## Inspection of a proposed subdivision at Windermere

*by B. D. Weldon*

Figure 1

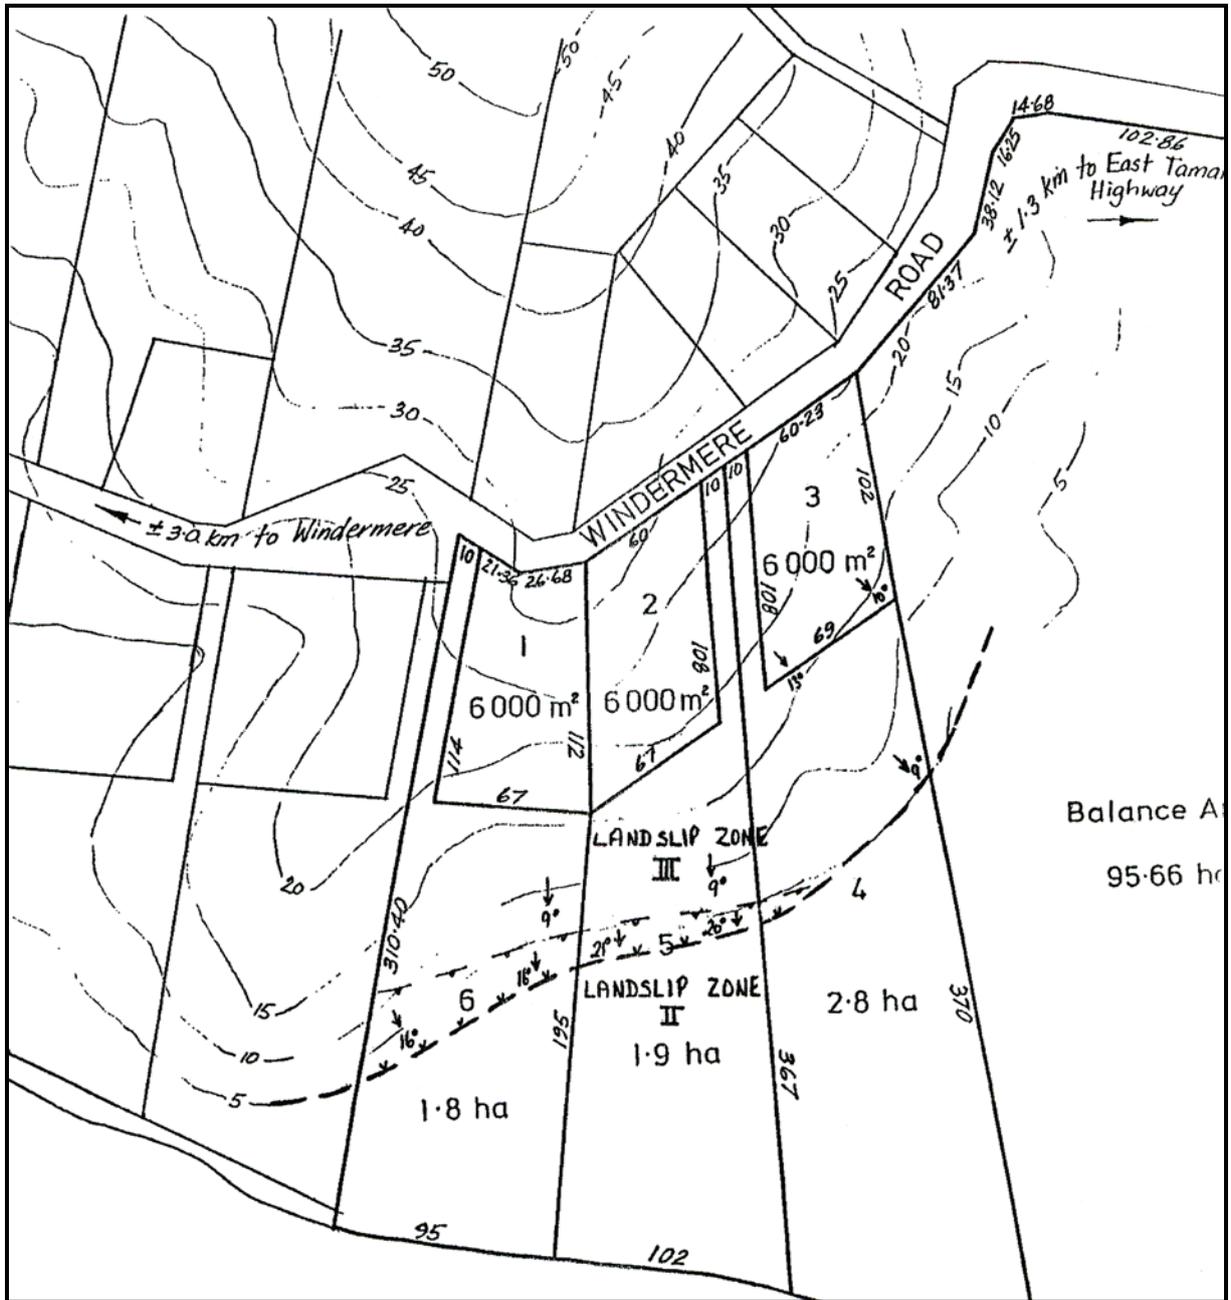
A proposed subdivision on the southern side of Windermere Road (fig. 1) was inspected. The proposal consists of the subdivision of six lots from the balance of the title. Three lots are 'internal' with frontages to Nelsons Shoal on the River Tamar. The lots are located on an undulating to rolling mid-slope segment and on the floodplain of the River Tamar. The floodplain segment is classified as landslip Zone II (i.e. stable ground but on soft rocks) on the advisory Tamar Valley Landslip Zone Map. The mid-slope segment is classified as landslip Zone III (i.e. potential landslip area).

The floodplain area, which encompasses about a third of the area to be subdivided, is unsuitable for housing as it is susceptible to flooding and water logging.

Relatively gentle sloping areas occur on all lots as well as steeper sloping parts. House sites should be selected on the flatter areas and not the steeper land. Housing should not be permitted on the steep slope subsegment (16–21°), which roughly parallels the boundary between landslip zones III and II on lots 5 and 6. Removal of trees from this steep slope subsegment is considered to be dangerous as it will detract from the stability of the slope subsegment and may initiate erosion and remove toe support to the slope above. Excavations on all lots should be kept to a minimum in height and any unsupported excavation should be made at a shallow angle and provided with drainage at the toe of the excavation.

Stormwater, sullage and septic tank water should not be allowed to discharge directly downslope and near to the house sites. Ideally this water should be piped around the slope from the houses and allowed to discharge some 25–40 m from them. As lots 1, 2 and 3 are relatively narrow, this may be difficult to achieve depending on the actual house site. It would be preferable to split lot 2 and combine the area with each of lots 1 and 3, thereby making two lots with a greater width along the slope. These lots could be correspondingly shortened in depth if desired. The advice of the local Health Inspector should be sought in relation to this matter. Trees planted in the discharge areas should assist in maintaining stability.

Individual house sites should be examined when detailed development proposals are prepared.
